Office Action Summary	Application No. 10/759,531	Applicant(s) WELBORN ET AL.	
	Examiner Hemant M. Desai	Art Unit 3721

DETAILED ACTION

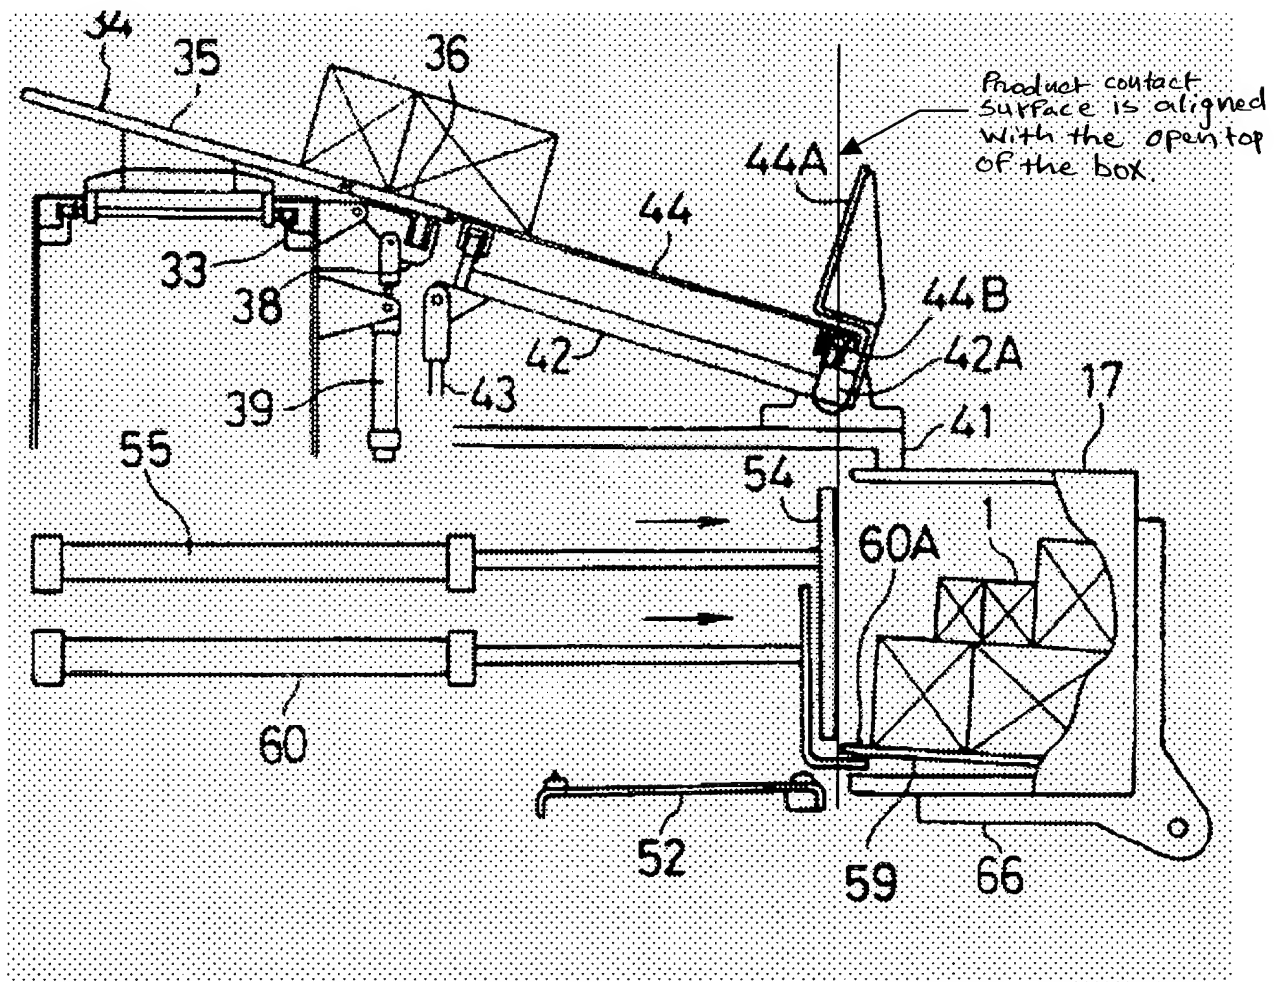
1. Applicant's arguments filed 11/23/2005 have been fully considered but they are not persuasive. In response to applicant's argument the above figure ^{Shows} ~~shows~~ that the product contact surface (44) is aligned with the open top of the box in the second angular orientation.
